Item ID: D3327-041 Accept ***N900040100*** Setup Start ***NS1***
Revision ID: Stop ***NS2***
Item Name: Basket Lid Assembly
Start Date: 4/11/2016 Start Qty: 1.00 ***1*** Cust Item ID:
Required Date: 4/15/2016 Req'd Qty: 1.00 ***1*** Customer:
Reference:

D3327-041 BASKET LID ASSEMBLY

DRAWING NO. D3327	TITLE BASKET LID ASSEMBLY	REV..B	DART AEROSPACE LTD ENGINEERING ORDER		D.E.O. NO. D3327-B-1	SHEET NO. SHEET 1 OF 1	SCALE NTS
DRAWN AJS	CHECKED <i>[Signature]</i>	MFG. APPR. <i>[Signature]</i>	APPROVED <i>[Signature]</i>		DE APPR. <i>[Signature]</i>		
DATE 08.11.28	DATE 08.11.28	DATE 08.12.01	DATE 08.12.01		DATE 08.12.01

DETAIL B
TYP. ATTACHMENT OF WEBBING TO LID
FRAME
(SCALE 1:1)

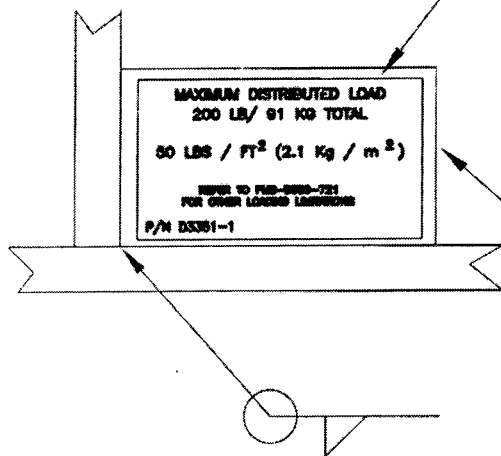
1) SHEET 1 MODIFY PARTS LIST AS SHOWN:

PART LIST FOR D3327-041 BASKET LID ASSEMBLY

Part No.	Quantity	Description

IS:

MS20600AD4W5	24	RIVET

WAS:

MS20600AD4W3	24	RIVET

2) UPDATE SHEET 3 DETAIL B ACCORDINGLY.
